Technical Bulletin

Bulletin No: 1007
Issue Date: 26/08/2003
Product: GX10i

Broken Diode D311

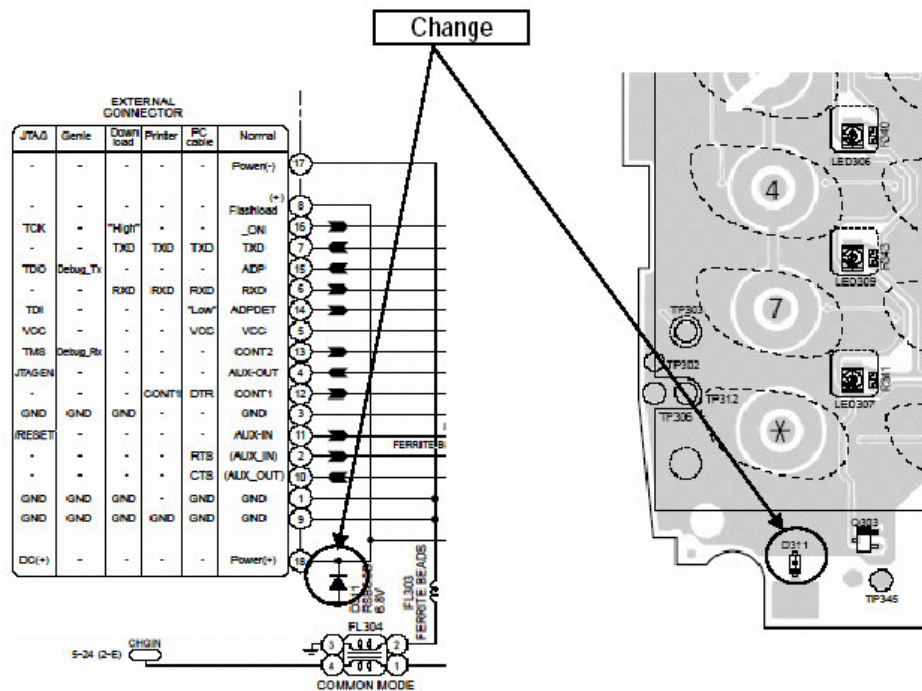
Diode D311 has been changed in the manufacturing process.

The modified diode is more resilient to the initial surge and will reduce the occurrence of the diode blowing during normal operation.

The old diode, Part Number VHERSB6R8S+-1L should no longer be used, the new diode Part Number VHD1SS388/-1 must be used instead.

It is not necessary to replace the diode unless it is found to be faulty.
